DESIGN REVIEW COMMITTEE

September 21, 2022 6:00 PM

**DEPARTMENT OF PLANNING AND ZONING
PLANNER'S REPORT**

DATE: September 15, 2022
TO: Tonya Hutson
FROM: Lynn Patterson
RE: **Design Review – 3154 Lake Ave Window addition**

PROPOSED
ELEVATIONS

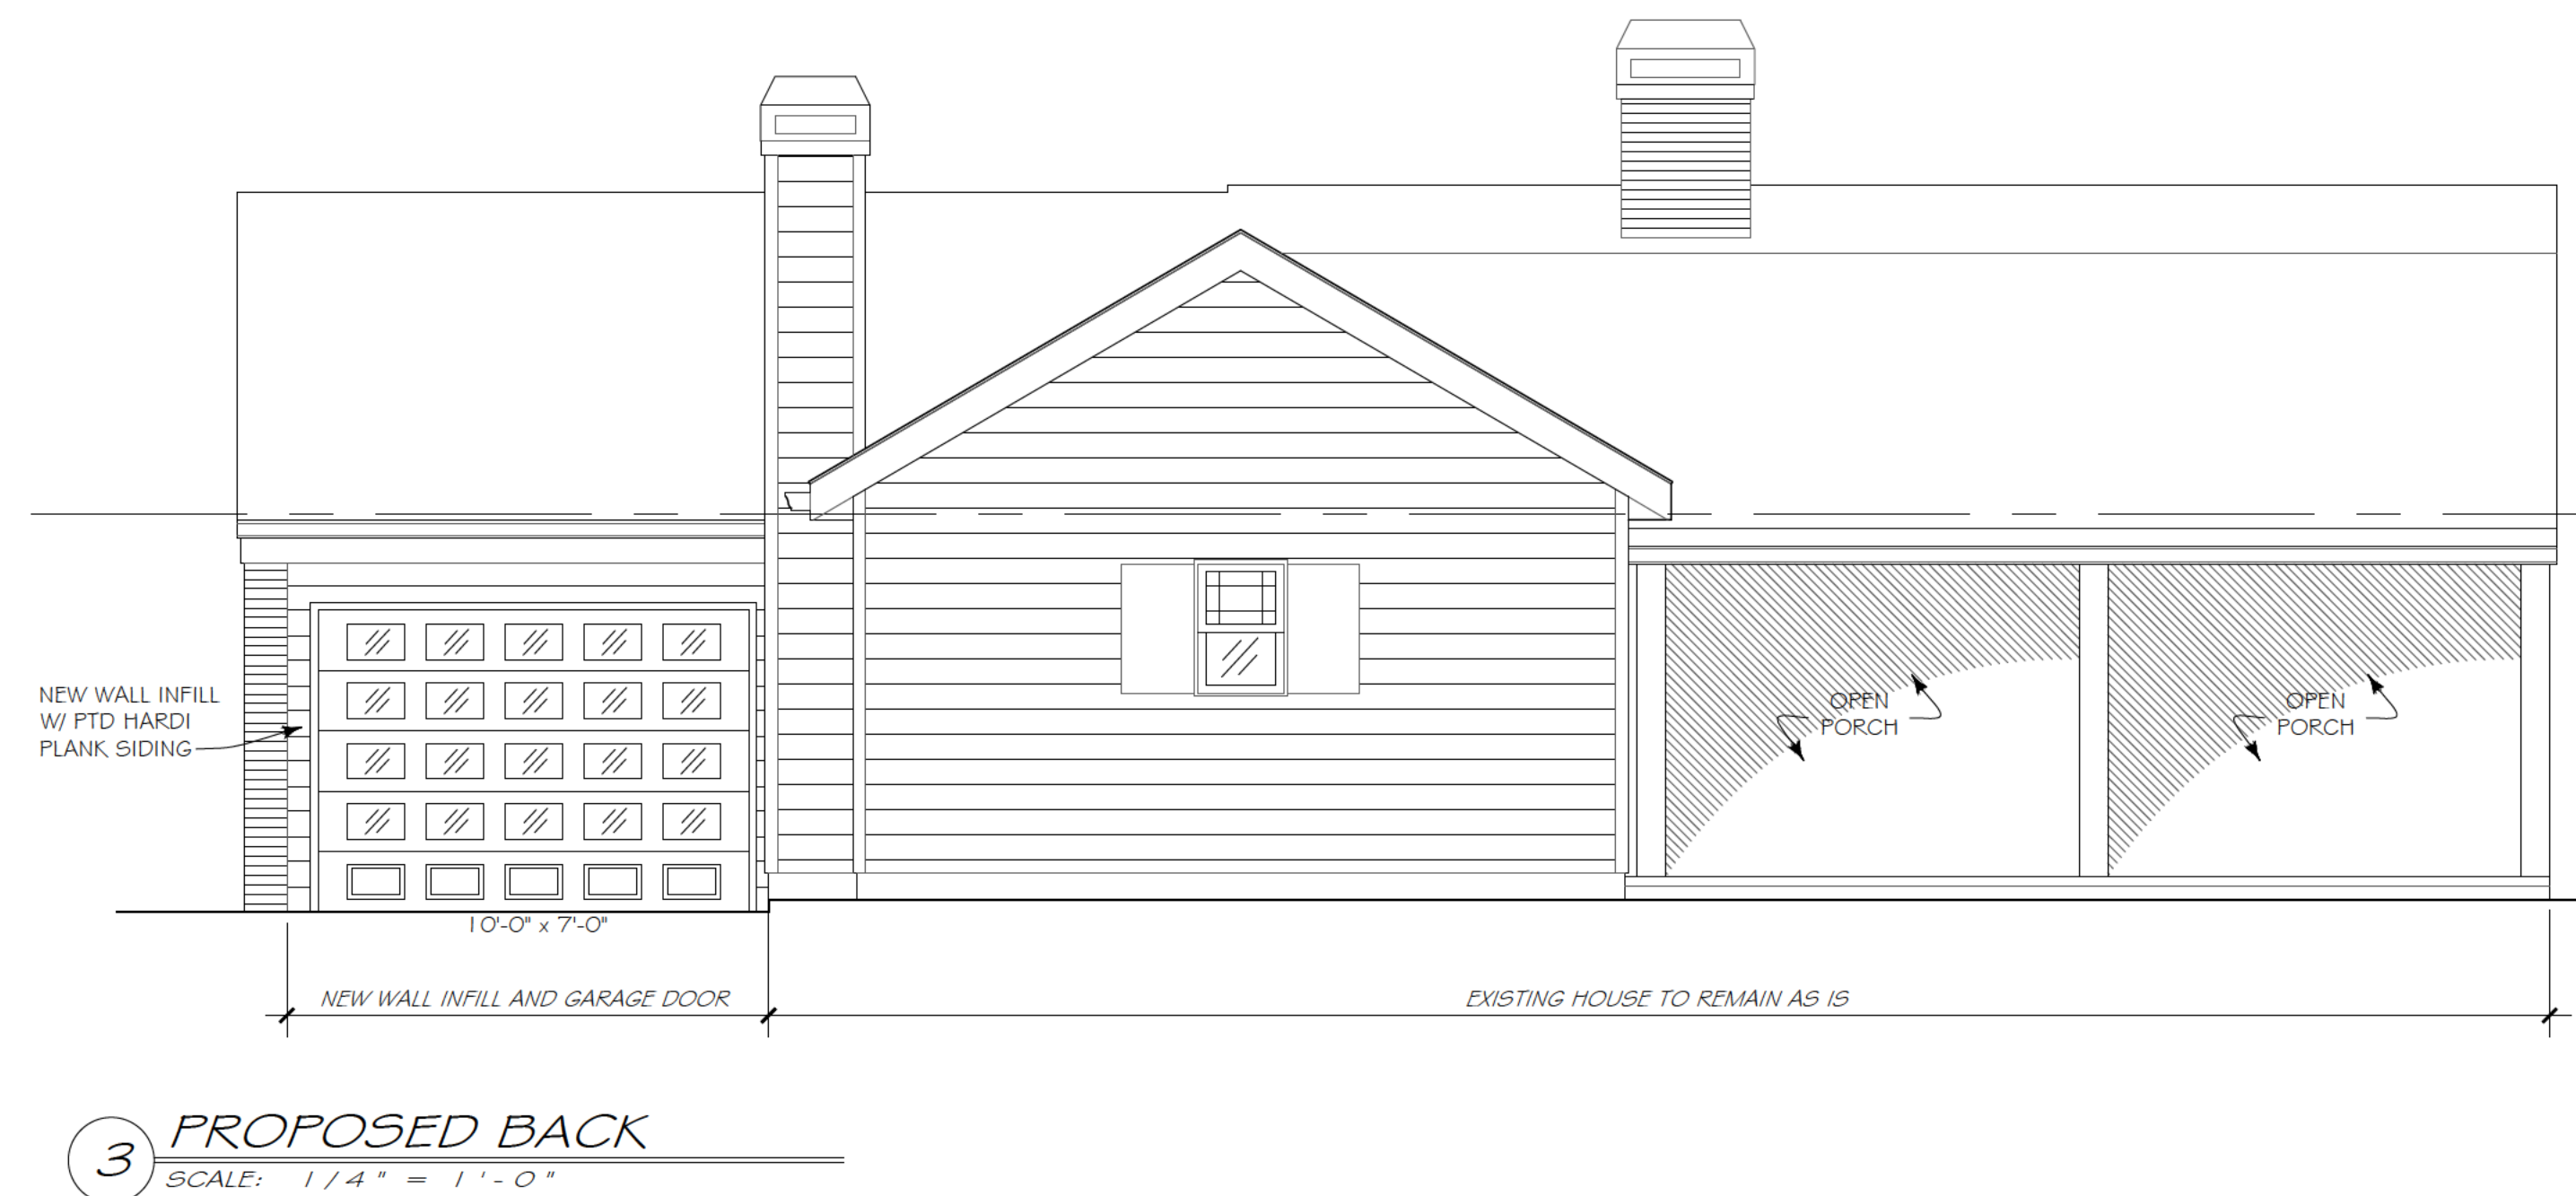
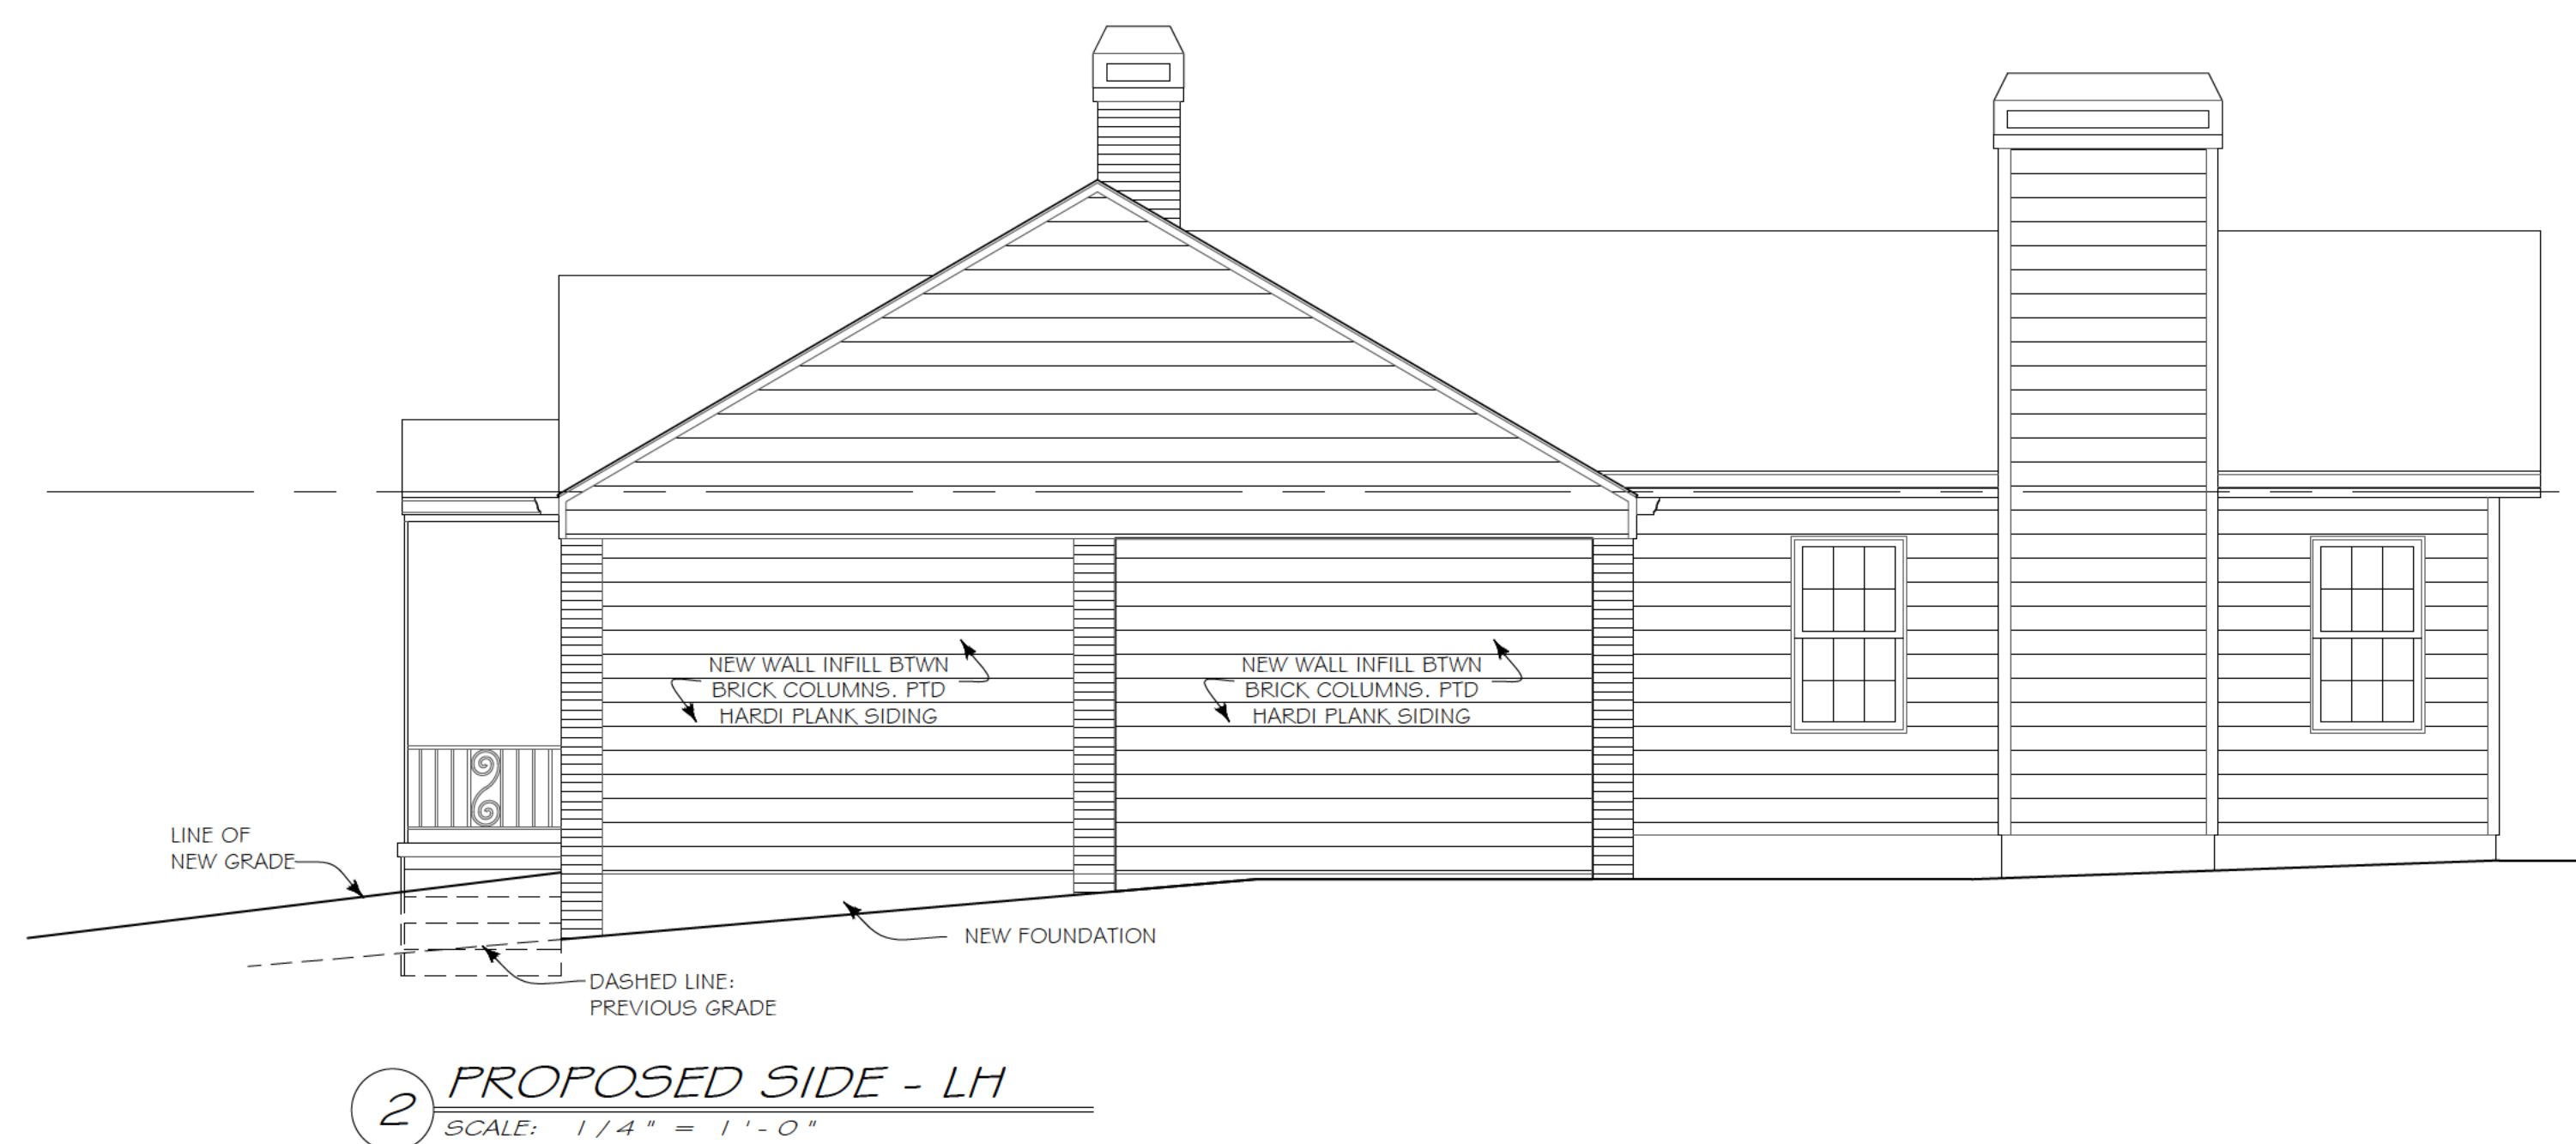
STAFF COMMENT: Existing carport to be enclosed. Design Exception required.
